ADDENDUM NO. 1

Date: April 27, 2016

Project: Playfield Renovations at Mark Hopkins ES

Designed: MZ	Project No. 3180047.101
Drawn: KT	Scale:
QAQC: MZ	Drawing No. L1.1
Date: 03/25/2016

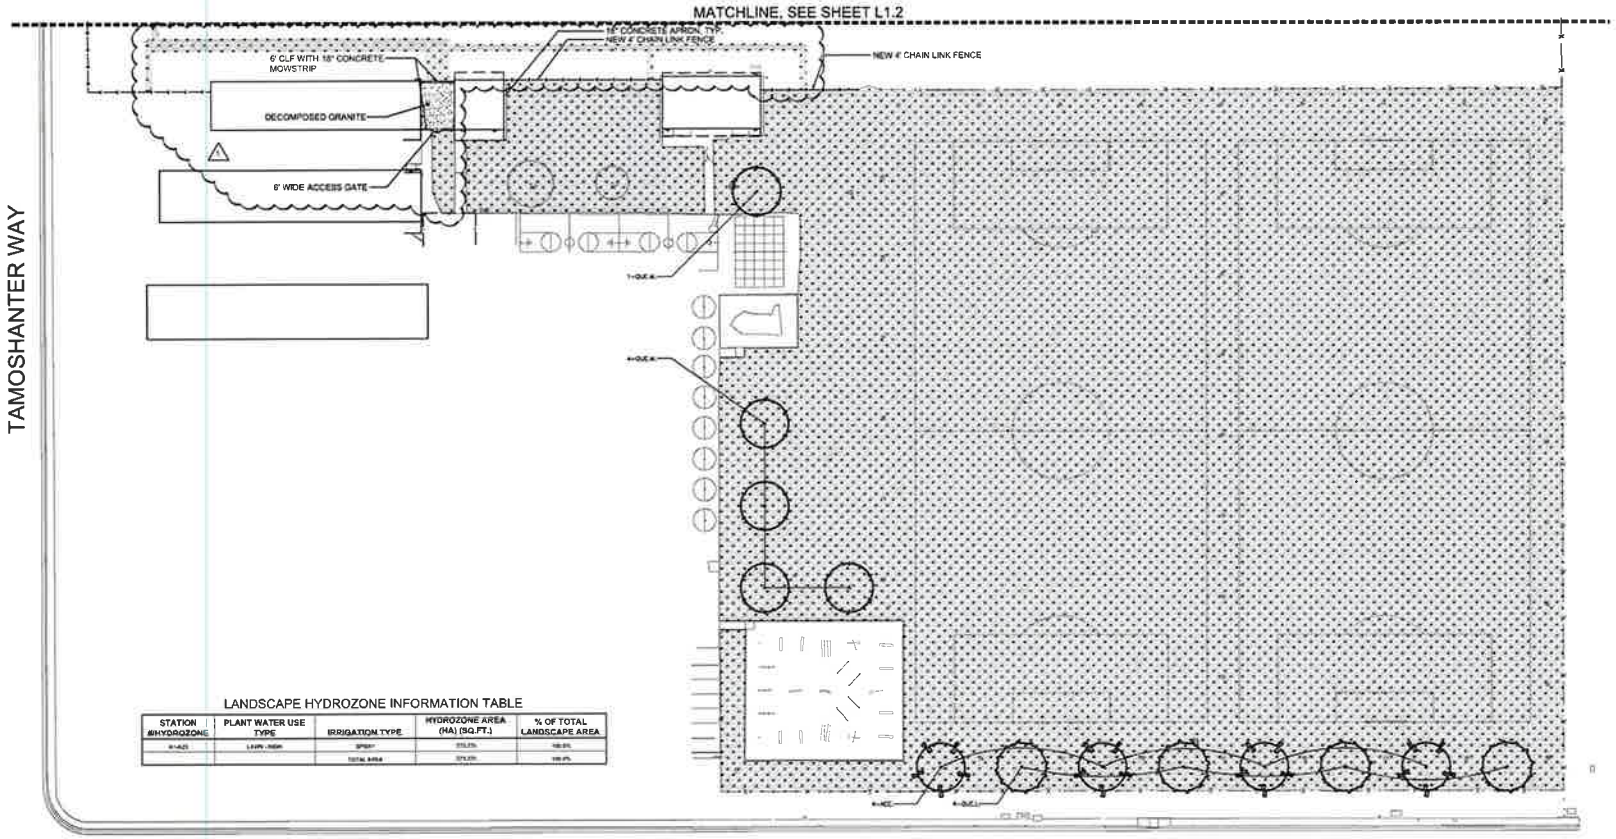
1. L1.1 – Sod patching updated to match the new trenching on L2.1, centered the gate to the irrigation yard on the fence section.

Designed: MZ	Project No. 3160047.101
Drawn: KT	Scale:
CADD: MZ	Drawing No. L1.2
Date: 03/25/2016

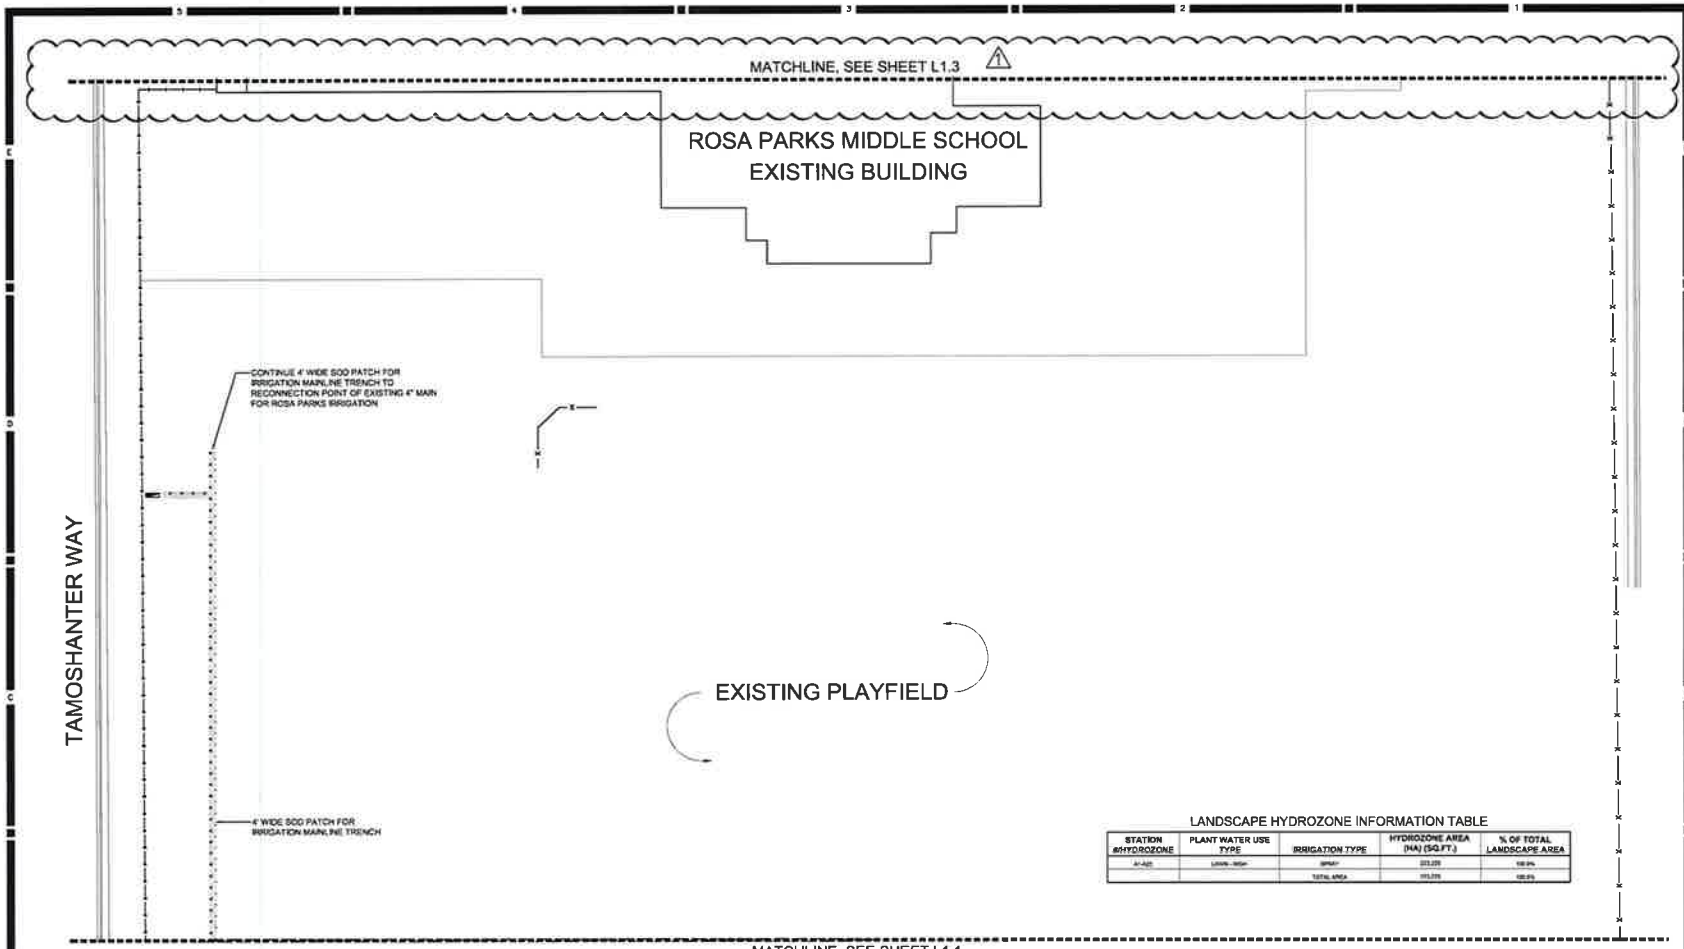
2. L1.2 – Matchline for L1.3 added.

Designed: MZ	Project No. 31M0047.101
Drawn: KT	Scale:
CHKD: MZ	Drawing No. L1.3
Date: 03/25/2016

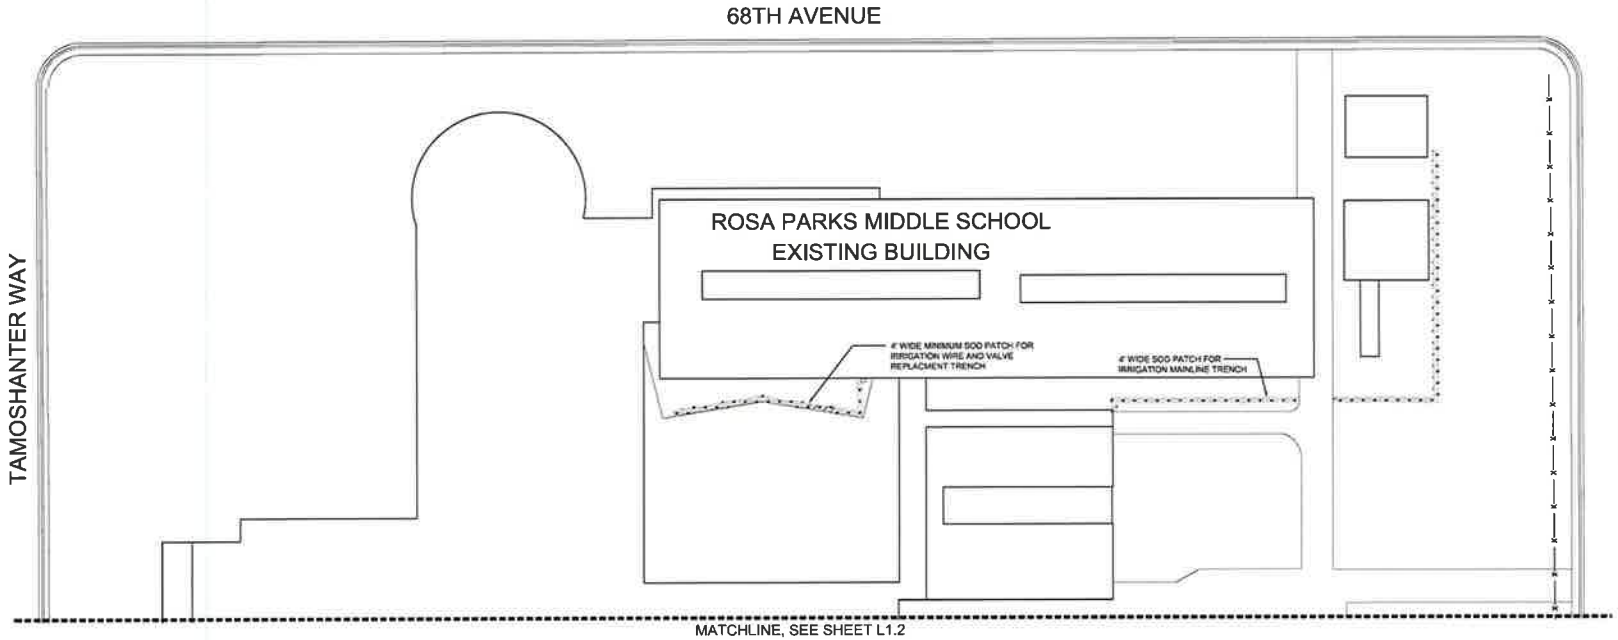
3. L1.3 – Additional landscape scope at Rosa Parks MS.

Designed: MZ	Project No. 3180047.101
Drawn: KT	Scale:
QAQC: MZ	Drawing No. L2.1
Date: 03/25/2016

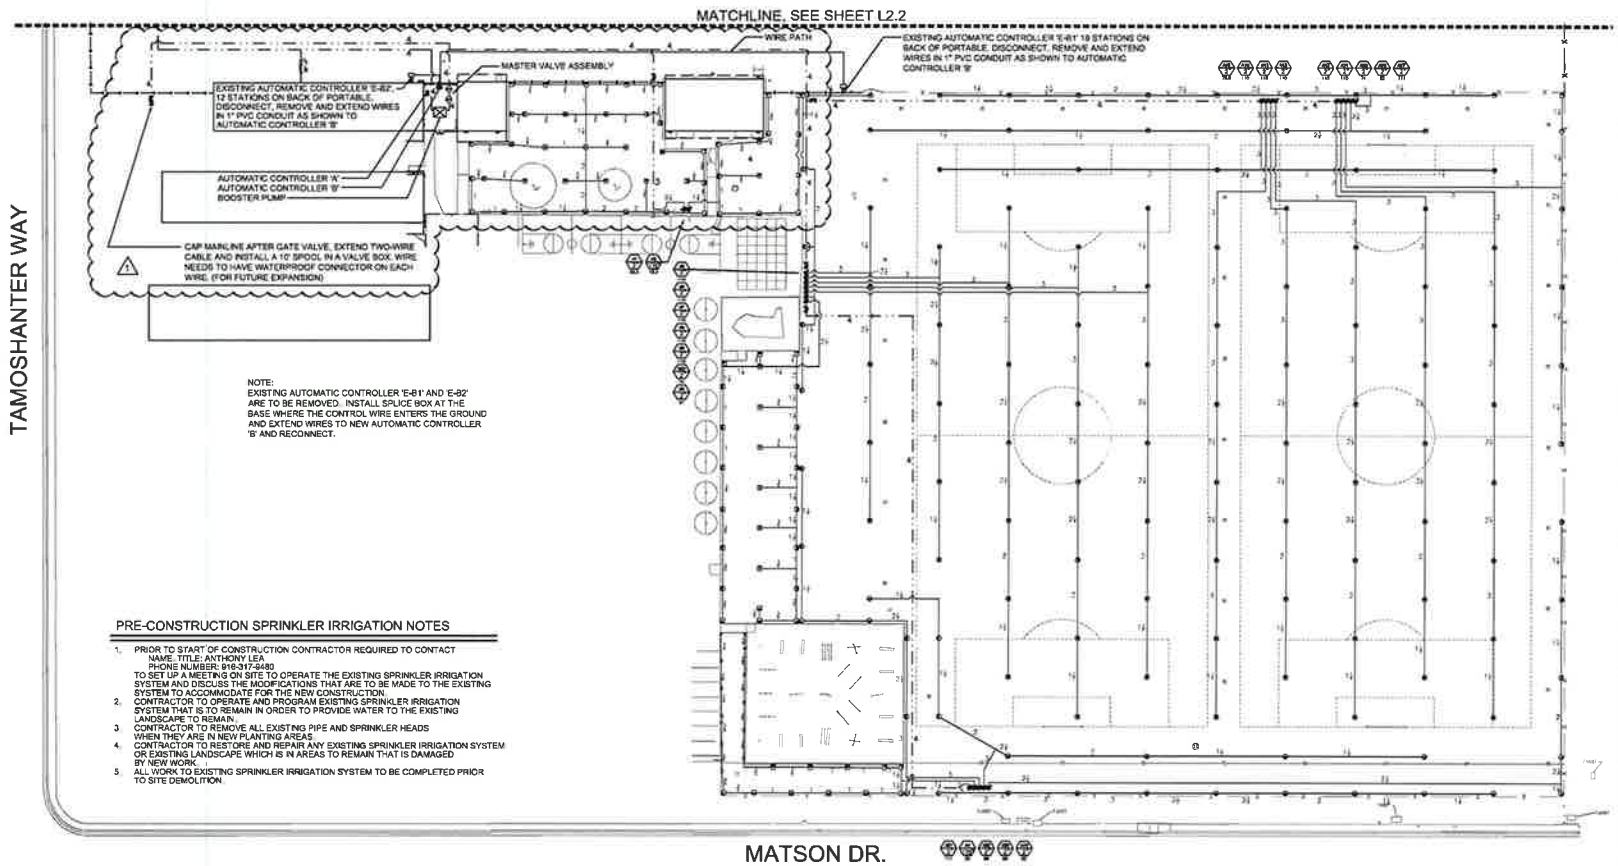
4. L2.1 – Move the supply mainline to the booster pump to run behind the portables in the Rosa Parks playfield, and moved the downstream mainline from the pump to run through the Rosa Parks playfield to the Mark Hopkins irrigation. Move the components in the irrigation yard around and added Automatic Controller B. Revised the Automatic Controllers in the legend.

Designed: MZ	Project No. 31880047.101
Drawn: KT	Scale:
CHKD: MZ	Drawing No. L2.2
Date: 03/23/2018

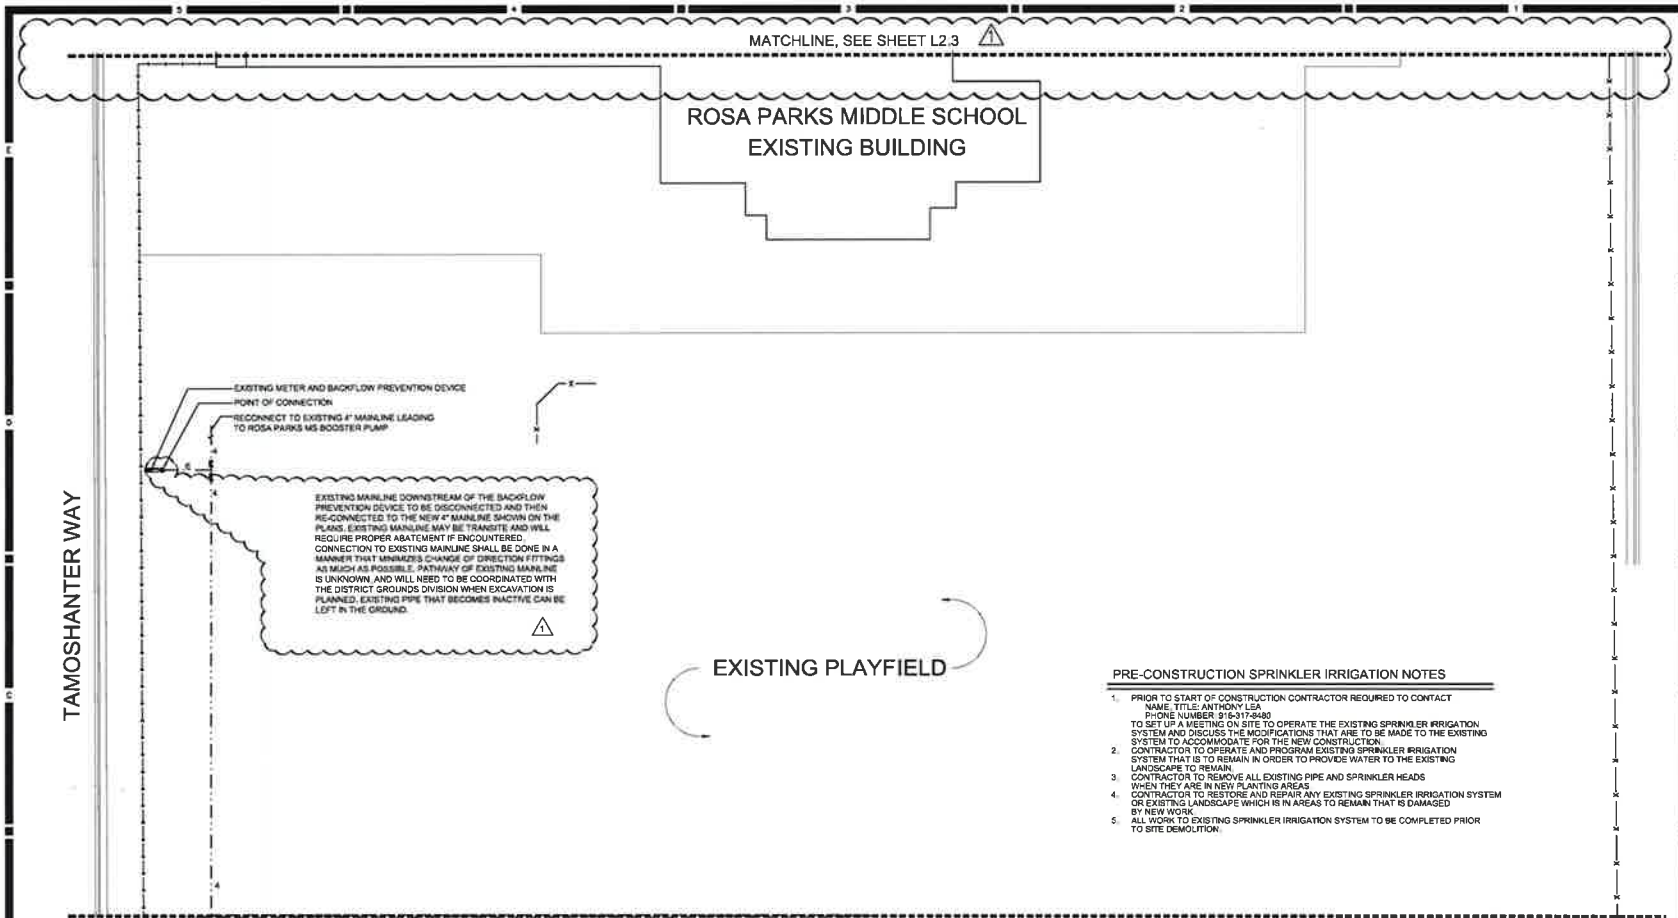
5. L2.2 – Matchline for L2.3 added, and note added to the point of connection.

Designed: MZ	Project No. 3188047.101
Drawn: KT	Scale
CHKD: MZ	Drawing No. L2.3
Date: 02/25/2016

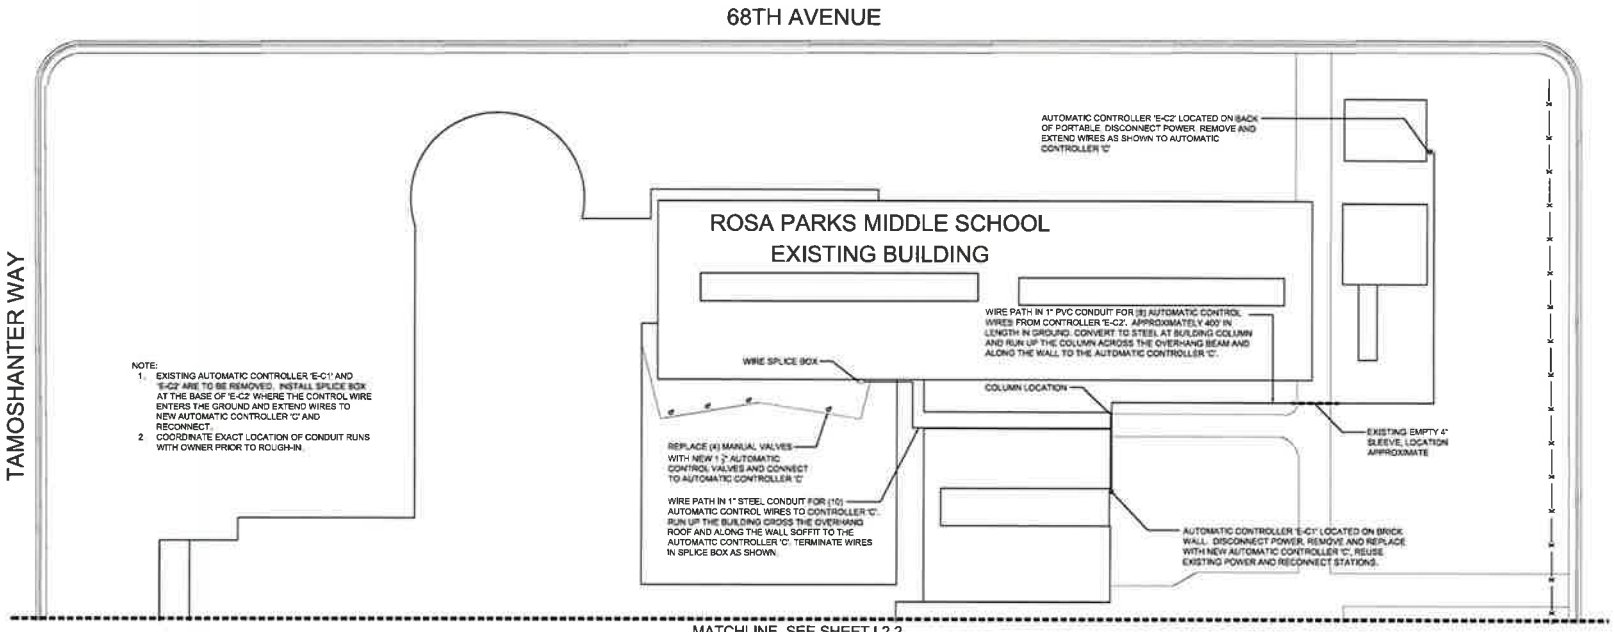
6. L2.3 – Additional irrigation controller scope at Rosa Parks MS.

A / E1.1 ELECTRICAL SITE PLAN
SCALE: 1" = 20'-0"

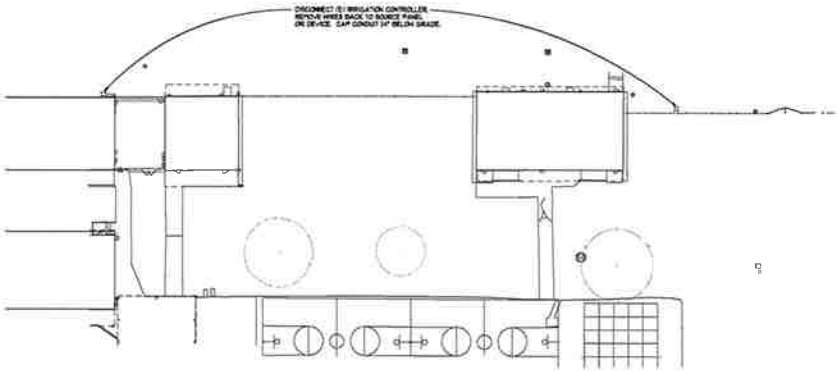
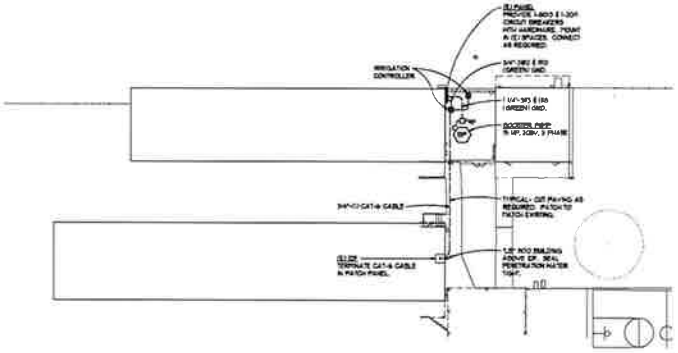
7. E1.1 – Electrical plan for power and data to irrigation equipment at Mark Hopkins ES.

A
E1.2
ROSA PARKS MIDDLE SCHOOL
ELECTRICAL SITE PLAN
SCALE: 1" = 30'-0"

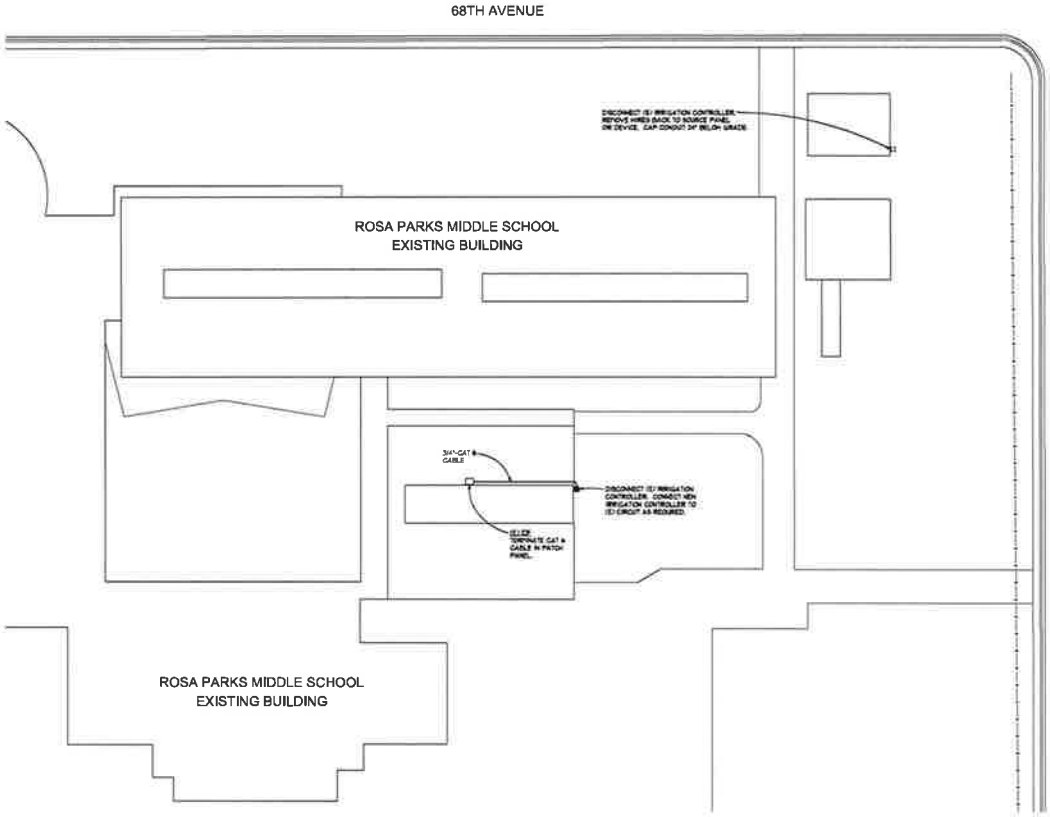
8. E1.2 – Electrical plan for power and data to irrigation equipment at Rosa Parks MS.
